**Re: Pio Pico Energy Center Project (11-AFC-01)
Staff's Questions Regarding Applicant's Responses to Data Requests 72 and 73**

Pio Pico Energy Center Project

Supplemental Responses to Biological Resources Data Request

Responses to Email Correspondence from CEC Staff Ann Crisp

FIGURE 9
VEGETATION COMMUNITIES ALONG
ESCONDIDO-PALOMAR UPGRADES

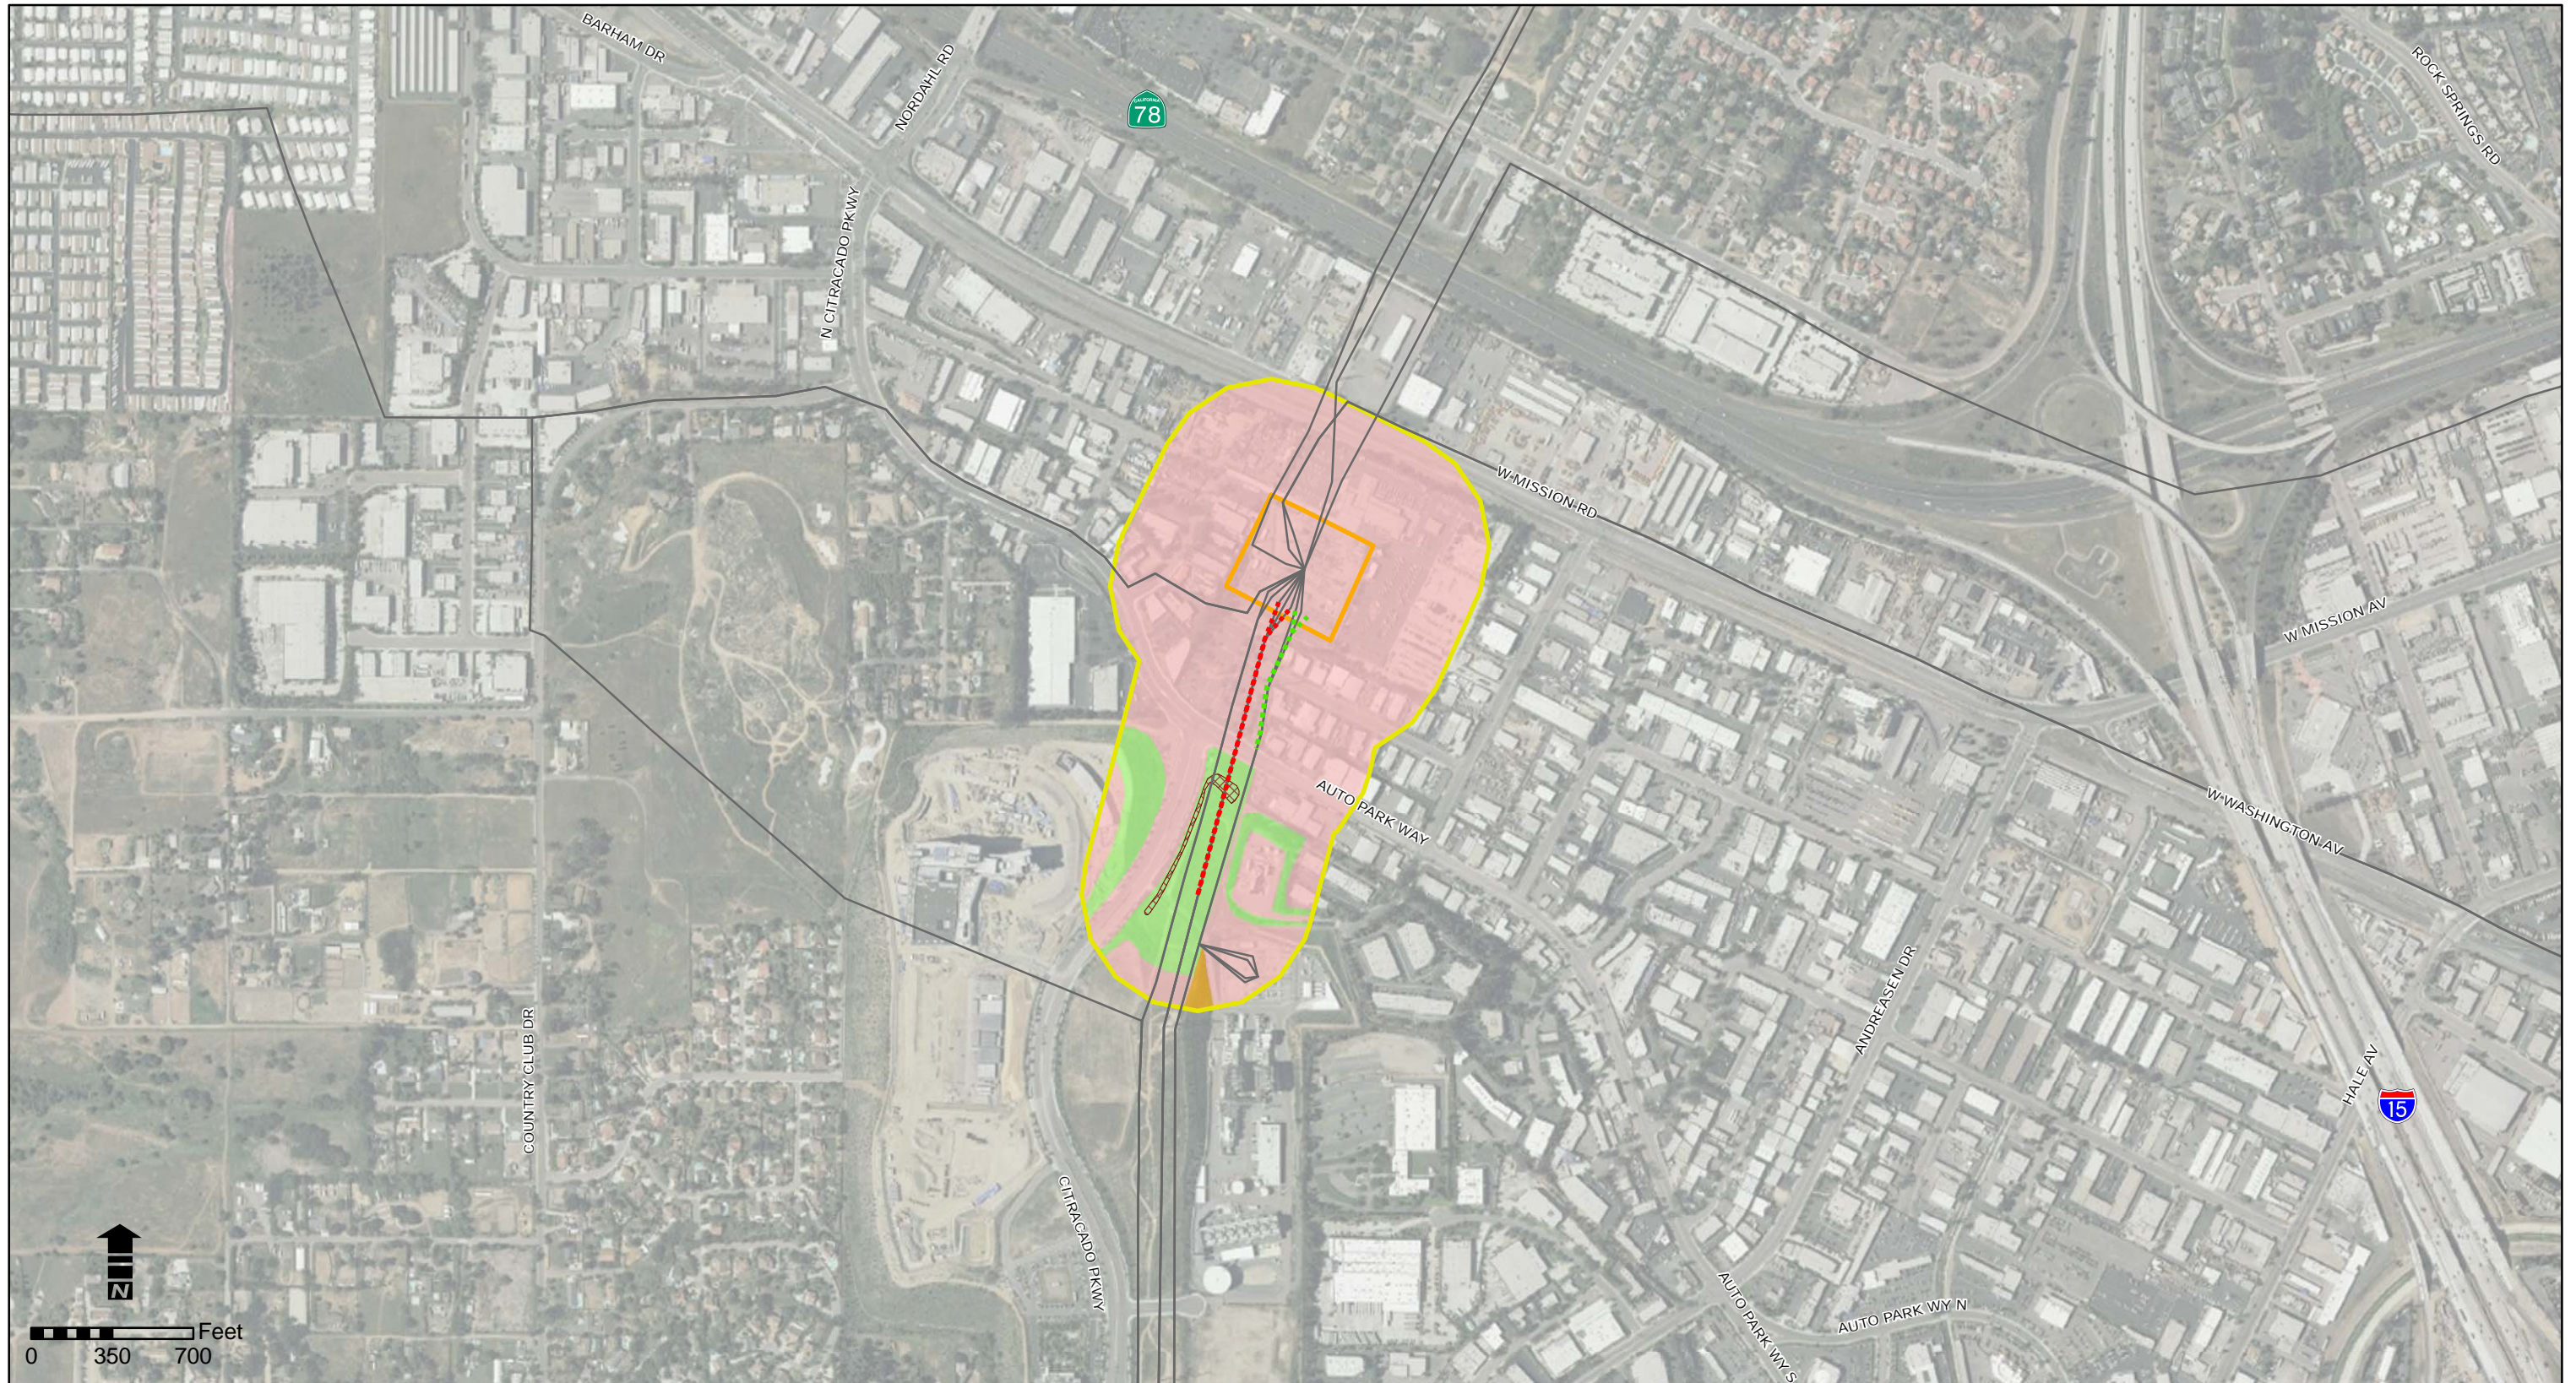
- 3. Location on a map of sensitive habitats (e.g. vegetation communities incl. coastal sage scrub; wetlands incl. all special aquatic resource areas) see data request 72h and 73h - the vegetation communities and special aquatic resource areas are identified in text but no map is provided.**

Exhibits A (Escondido – Palomar line) and B (Friars – Doublet line) illustrate vegetation communities and potential aquatic resources within the study area.
